**PJM Interconnection  
Artificial Island (AI) Project  
Analysis & Risk Assessment**

**PJM Interconnection, L.L.C  
2750 Monroe Blvd.  
Valley Forge Corporate Center  
Audubon, PA 19403**

Exponent  
Abdel-Aty Edris  
149 Commonwealth Drive  
Menlo Park, CA 94025

Date April 8, 2015

Figure 2 TCSC Scheme

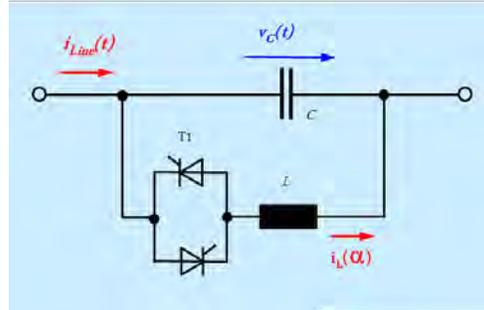
- Dominion did not provide any design detail of the TCSCs in terms of the size of the C and L in the TCSC scheme shown in figure 2. The designed sizes of the C and L determine the curvature of how the equivalent capacitive reactance  $X_{tcsc}$  is changing as function of the firing angle  $\alpha$ . Furthermore, the proximity of the operating, steady state, firing angle  $\alpha$  with respect to  $\alpha_{res}$  and how close the firing angle at post-contingency, where the compensation degree will be ramped up to 90% compensation, to  $\alpha_{res}$ . It is, therefore, very important to appropriately design the C and L parameters of the respective TCSC to make sure that there will be enough marginal distance such that the operating firing angle  $\alpha$  will not drift to  $\alpha_{res}$  region at which the TCSC will be acting as a circuit breaker, open circuiting the compensated transmission line.

2. **Design detail of the TCSCs**, the capacitance C, the inductance L, and, therefore, the firing angle  $\alpha$  corresponding to the required compensation degree, as indicated in the figure 2. This will result in determining the shape of the  $X_{tcsc}$  characteristic shown in figure 4 and firing angle  $\alpha_{res}$  that should not be allowed to avoid the parallel resonance condition of the TCSC.
3. Conducting a study determining how the TCSCs, at different compensation degree levels, affect the voltage profile of the compensated line and, therefore, avoid operational problems.

Figure 4  $X_{tcsc}/X_c$  characteristics as function of the firing angle  $\alpha$  at different  $K$  values

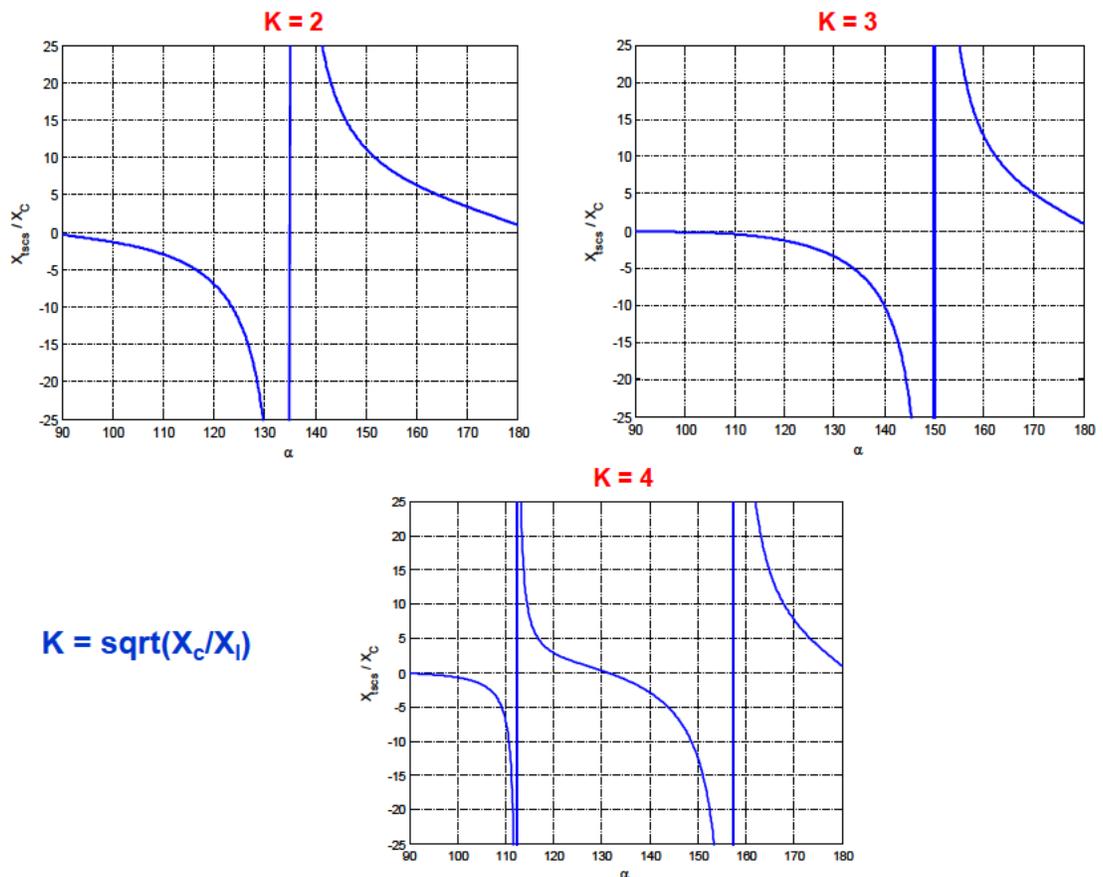
Since  $X_c$  is determined by the steady state compensation degree at  $\alpha$  equal to  $\pi$  the choice of  $X_1$  will determine the shape, curvature, of the  $X_{tcsc}$  characteristic as function of the firing angle  $\alpha$  and the permissible range of variation of  $\alpha$  before reaching  $\alpha_{res}$ . In other words, the value of  $\sqrt{X_c/X_1}$ , in the above  $X_{tcsc}$  expression, is a very critical parameter in designing the TCSC since it affects the operating characteristic of the equivalent compensation degree as function of the firing angle  $\alpha$  and the proximity of the operating point to the parallel resonance point. For a practically functioning TCSC, the  $\sqrt{X_c/X_1}$  must be greater than one and lower than a critical value. If the  $\sqrt{X_c/X_1}$  is less than one,  $X_{tcsc}$  will only have the capacitive part of the characteristic on the whole range of  $\alpha$ , i.e.,  $\pi/2 \leq \alpha \leq \pi$ . On the other hand if the  $\sqrt{X_c/X_1}$  is larger than a critical value the  $X_{tcsc}$  characteristic shown in figure 3 will have more than one resonance points, which means a serious limitation of the operating function of the TCSC. Therefore, the value of  $X_1$  should be optimally designed to obtain the desired characteristic of  $X_{tcsc}$ , in terms of curvature, proximity of the operating point to the resonance point, and the practical operating region of the firing angle  $\alpha$  between  $\pi$  and  $\alpha_{res}$ .

For illustration, Figure 4 shows the characteristic of  $X_{tcsc}/X_c$  as function of the firing angle  $\alpha$  at different values of  $k = \sqrt{X_c/X_1}$

Figure 5 Spring-Mass model for n-mass turbine-generator shaft system

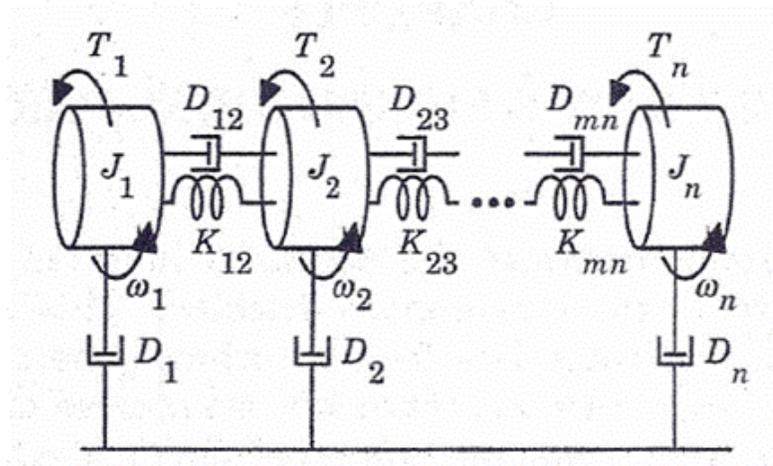
1. More accurate **Spring-Mass model** representation of turbine-generator shaft system of the nuclear power plants, Salem 1 Unit, Salem 2 Unit and Hope Creek Unit.

The manufacturers of those nuclear units should be consulted to provide the parameters shown in the figure below based on design values of the respective turbine-generator shaft systems.
